TRI-STATE GENERATION AND TRANSMISSION ASSOCIATION, INC.

**RE: New Horizon Mine (Permit No. C-1981-008)
Technical Revision No. 9 (TR-99)
Pond 013 Limestone Inlet**

CHANGE SHEET FOR PERMIT REVISIONS, TECHNICAL REVISION, AND MINOR REVISIONSMine Company Name: New Horizon MineDate: **March 30, 2020**Permit Number: **C-1981-008**Revision Description: **TR-99 Pond 013
Limestone**

Pond 013 Design

MAP 2.05.3(3)-18

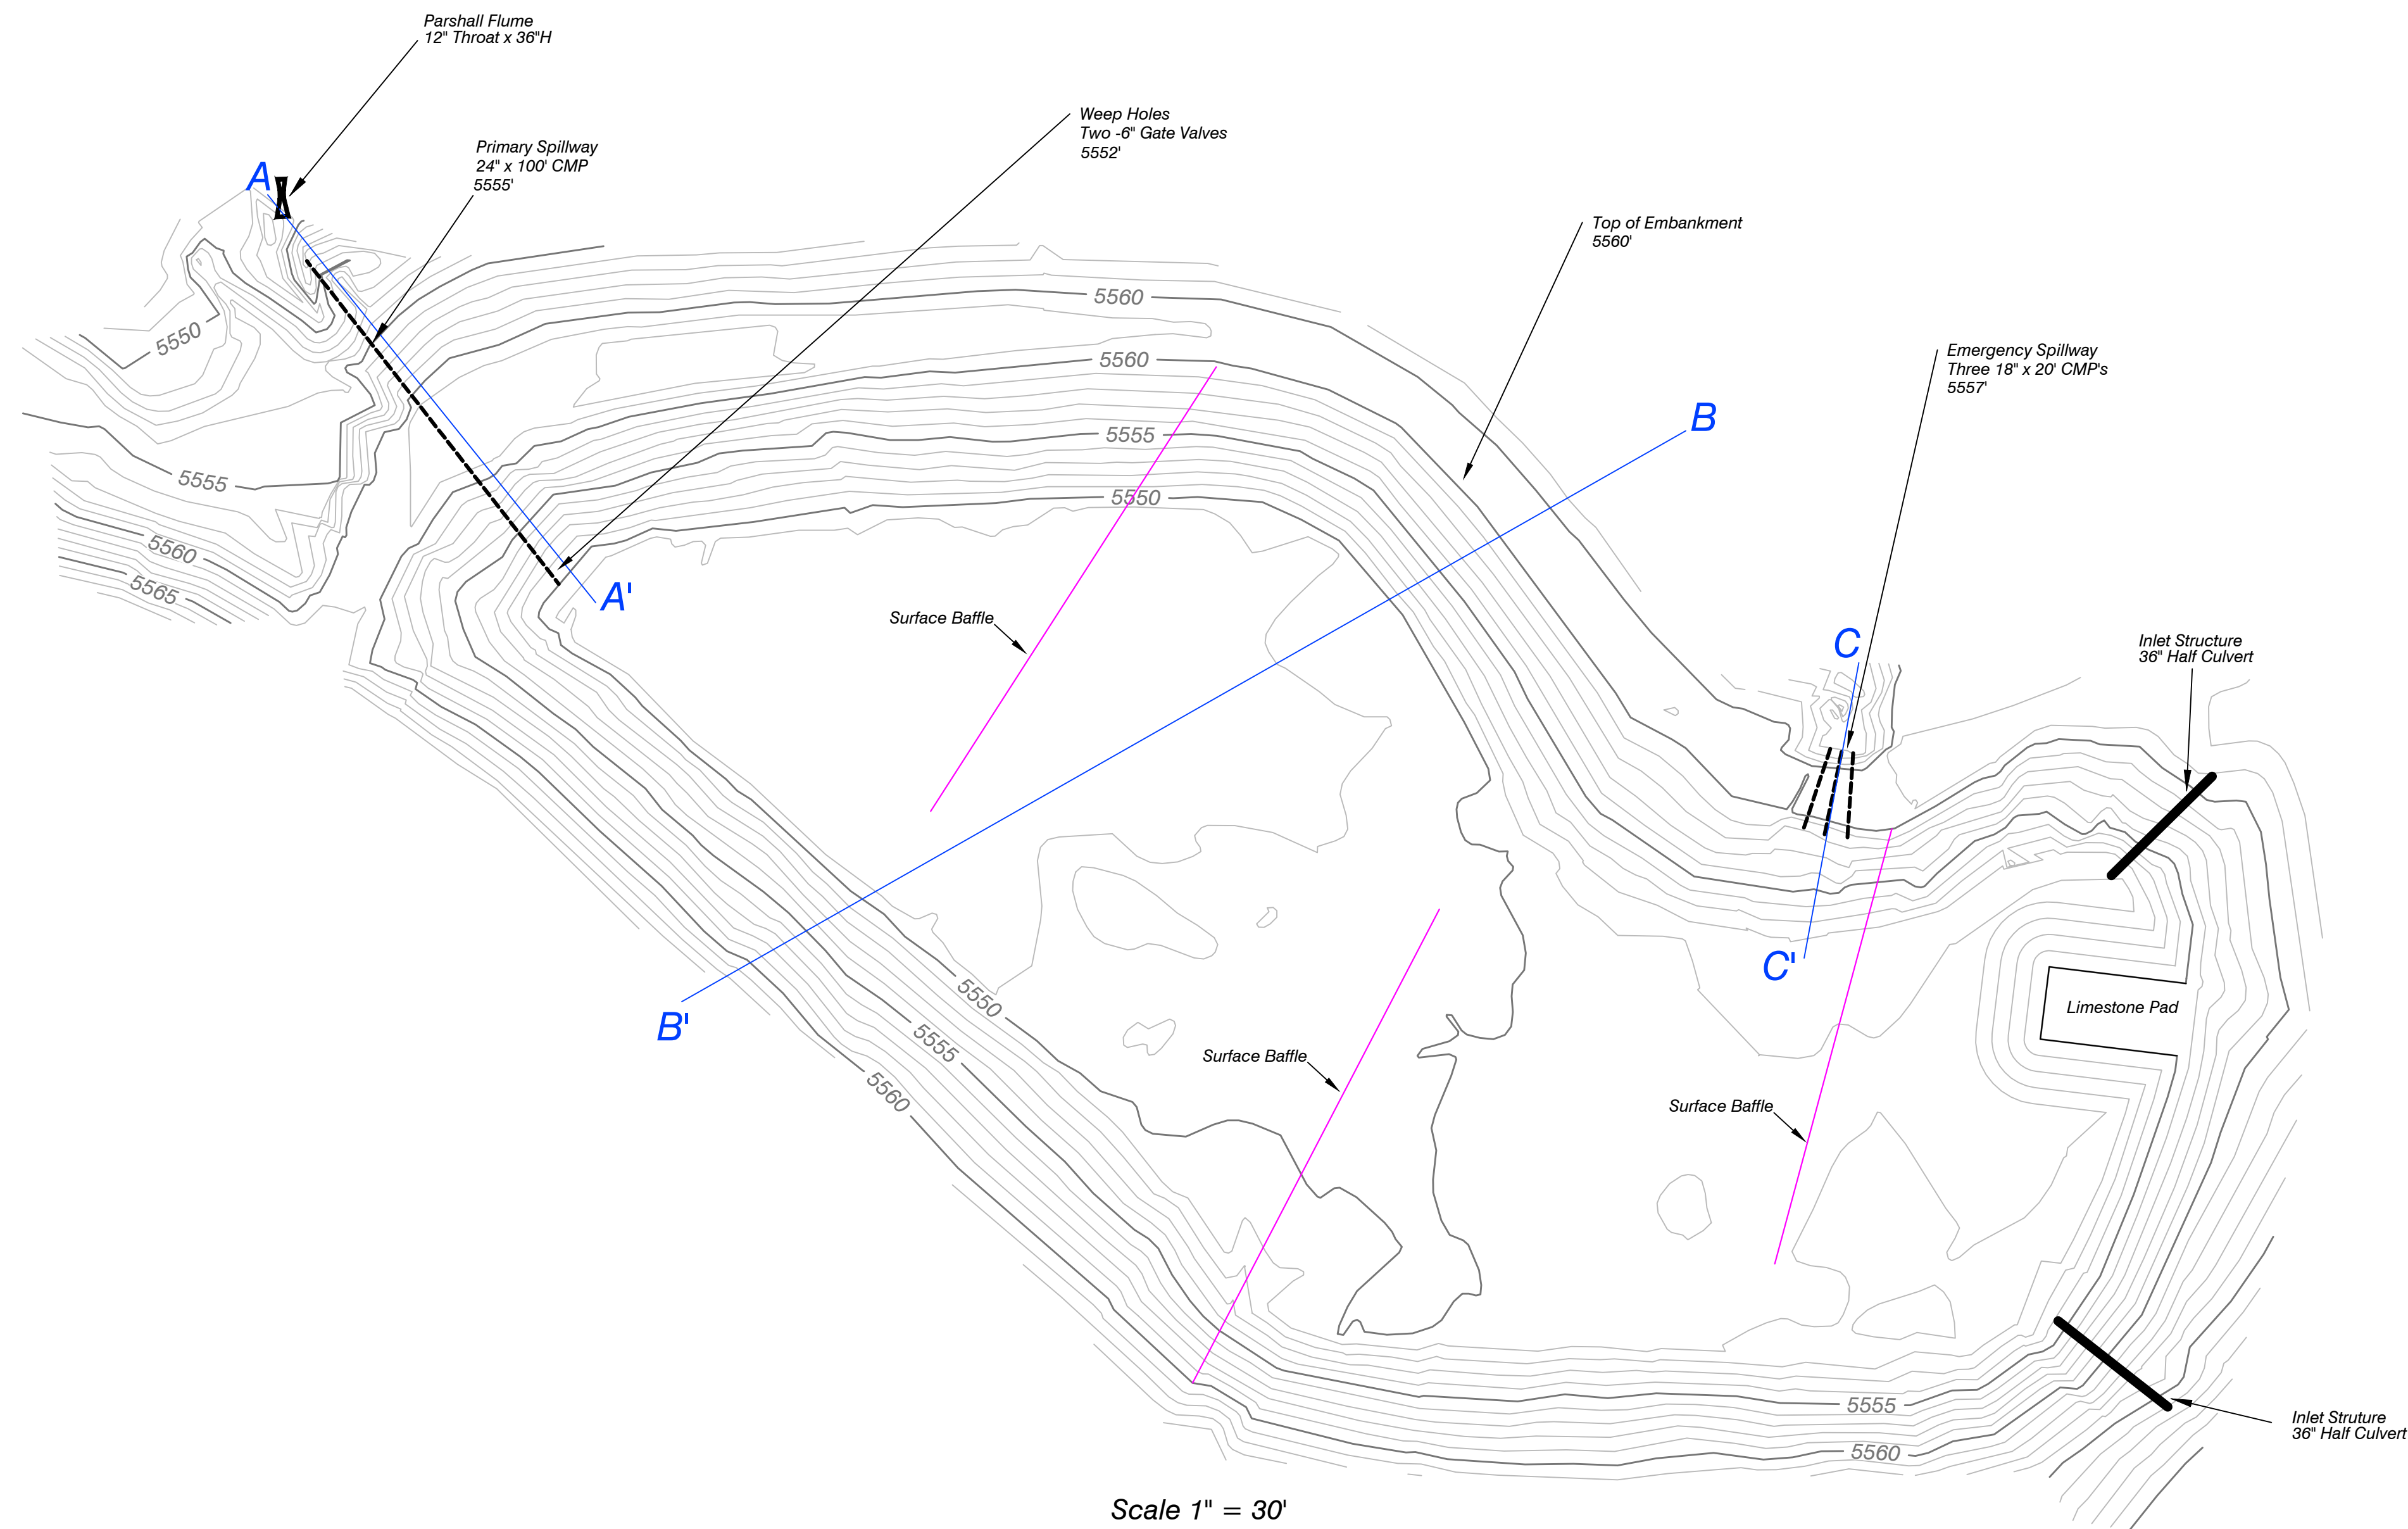
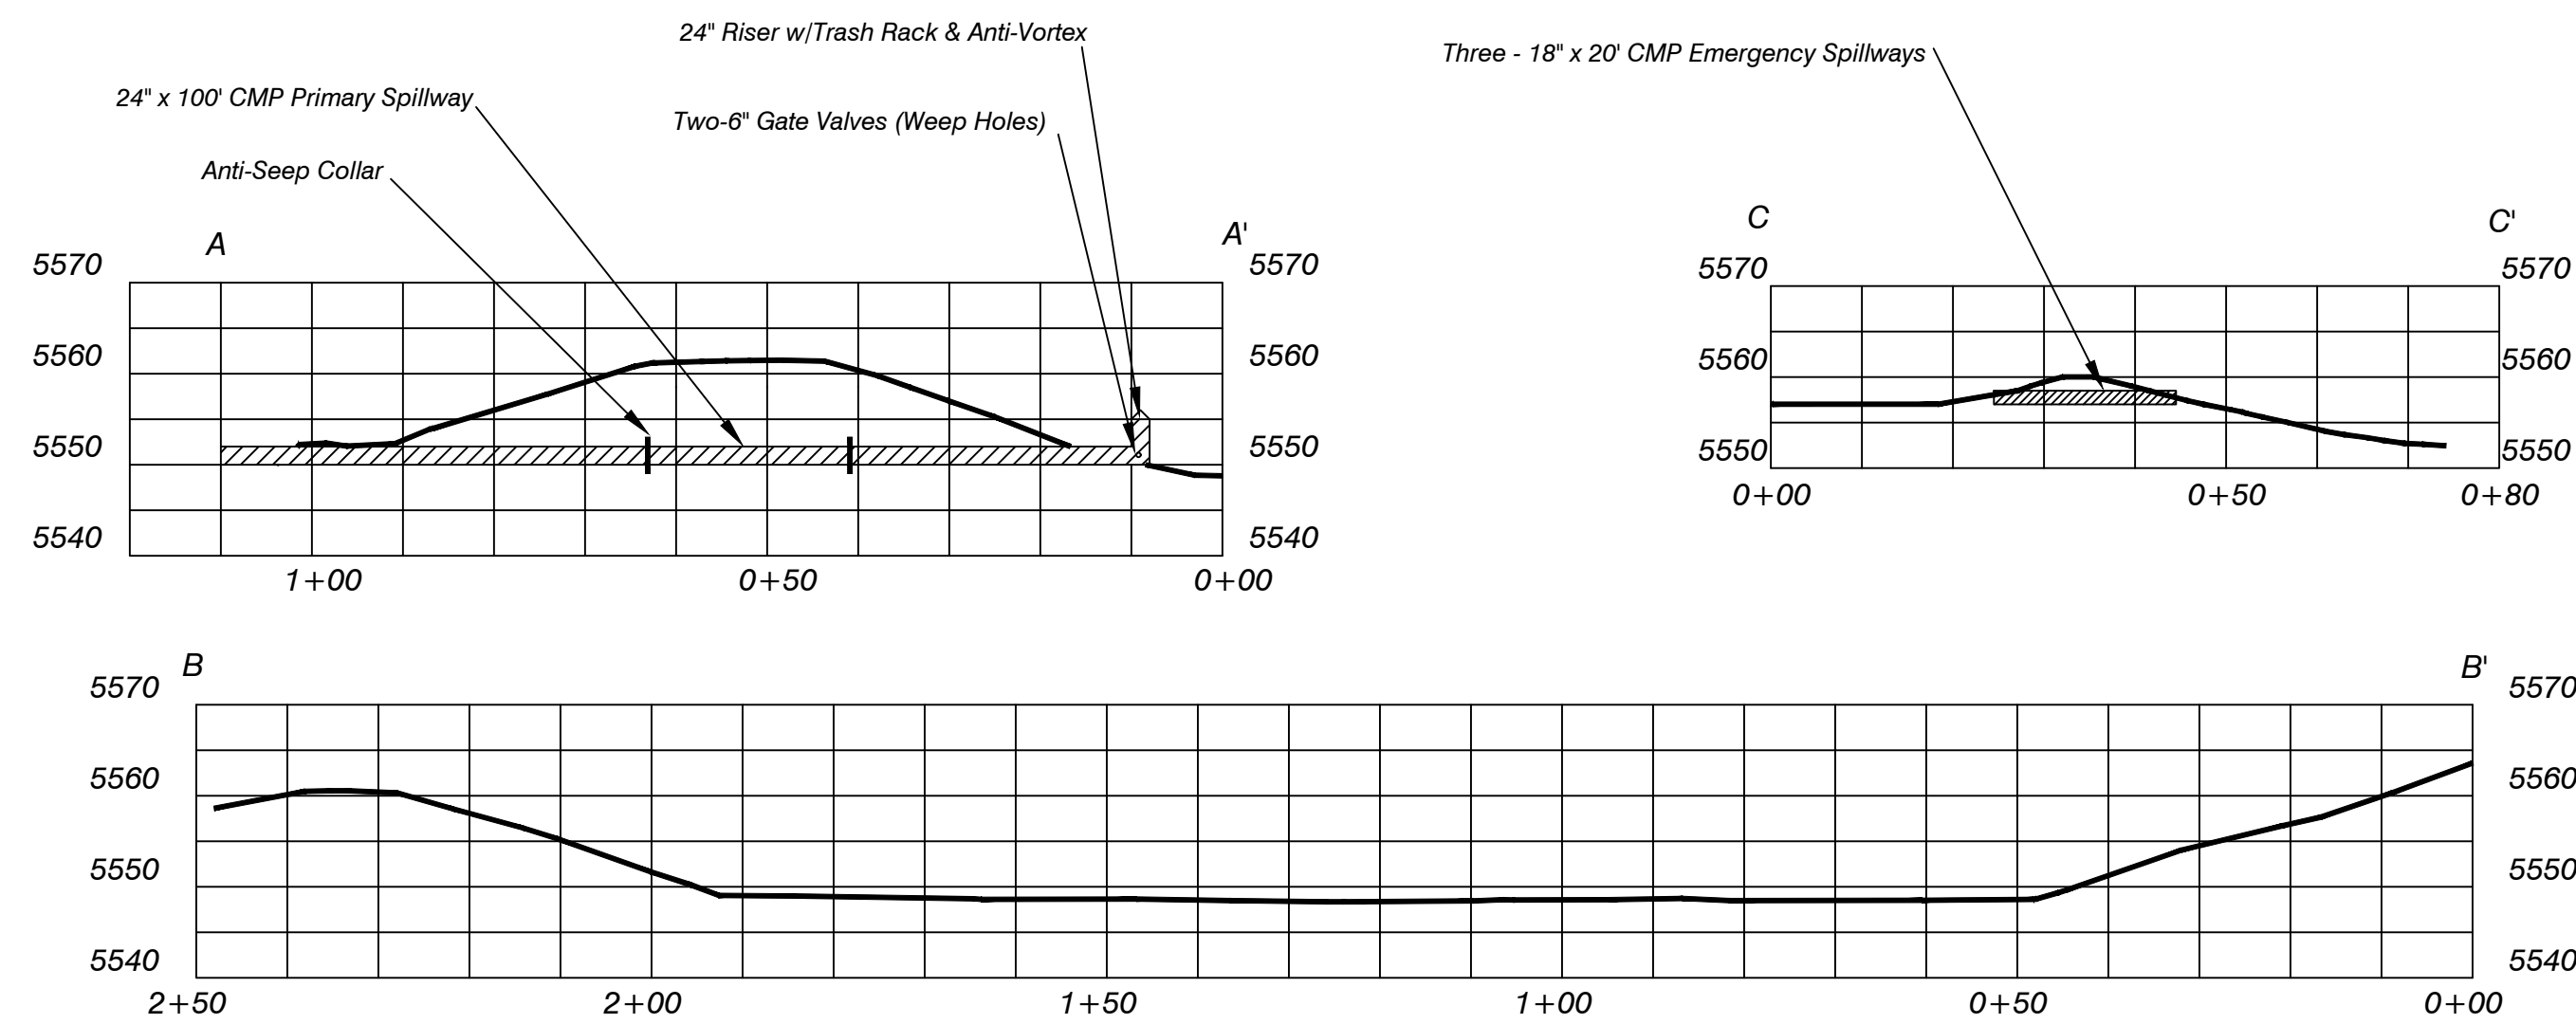
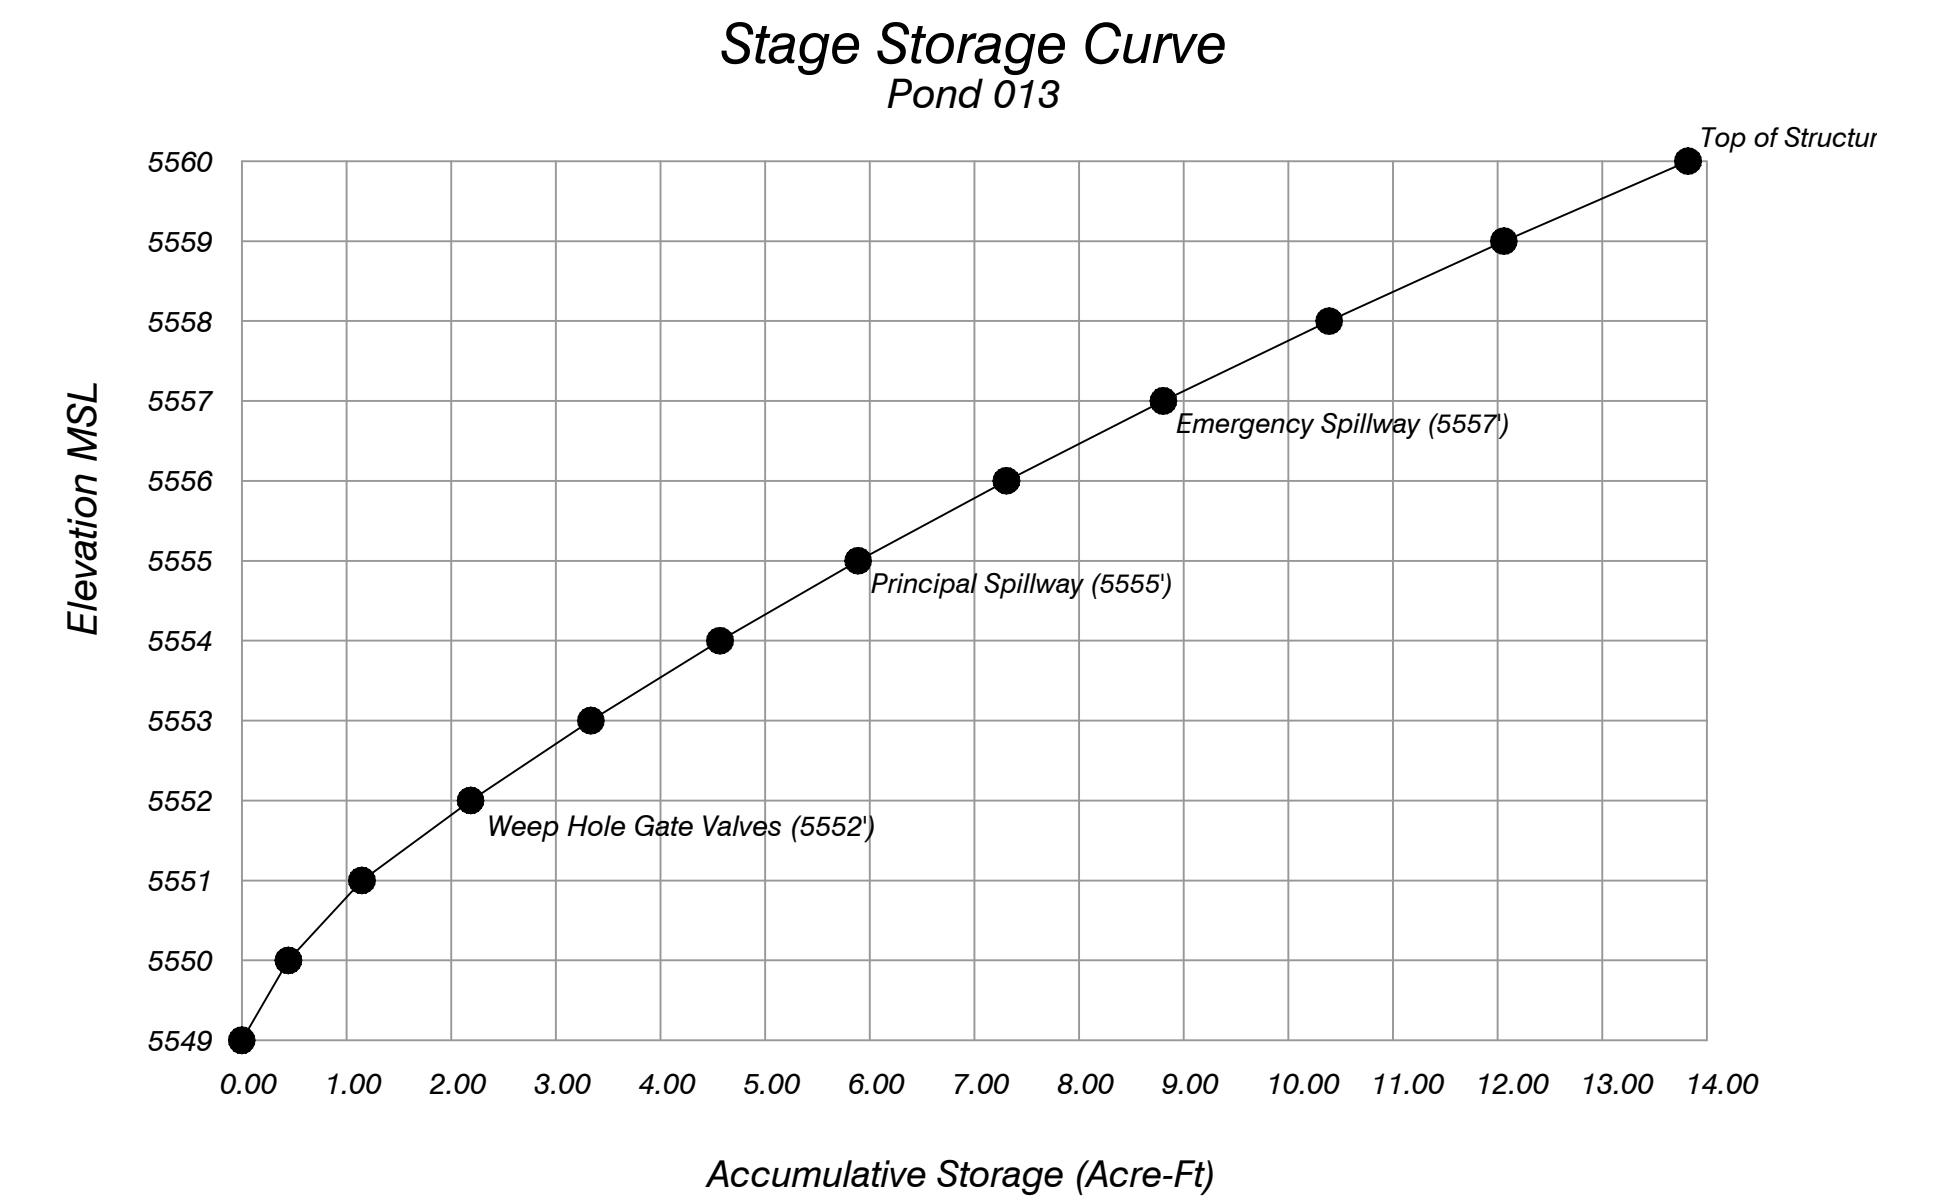
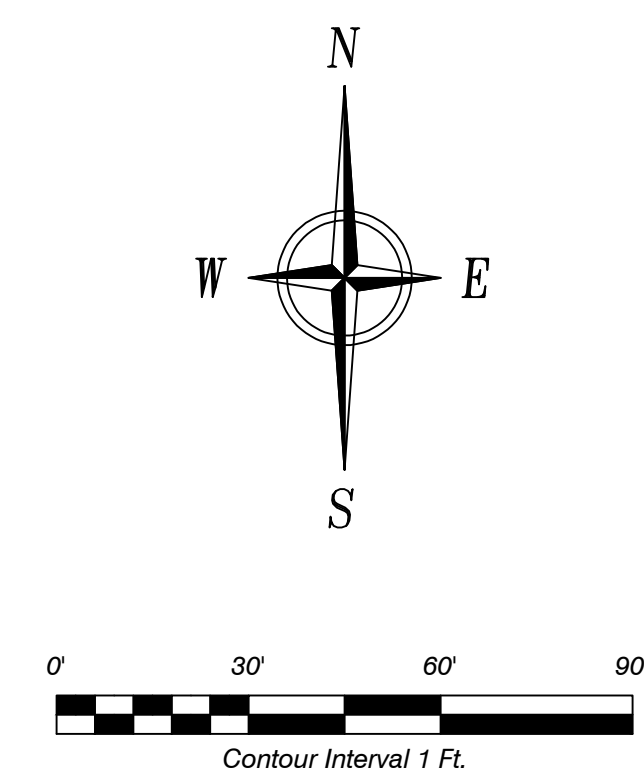
No.	REVISION	DATE	BY	CHK
PR-06	Change in Title Block	10/11/10	GL	DA
TR-70	Added SE Inlet, Corrected Flume Size, and a New Profile to Show Emergency Spillway Correctly	12/21/15	RLG	FKF
TR-99	Revised Drawing Layout, Added Limestone Pad, and Updated Stage Storage Curve, Revised Scale	3/30/20	Tony	FKF
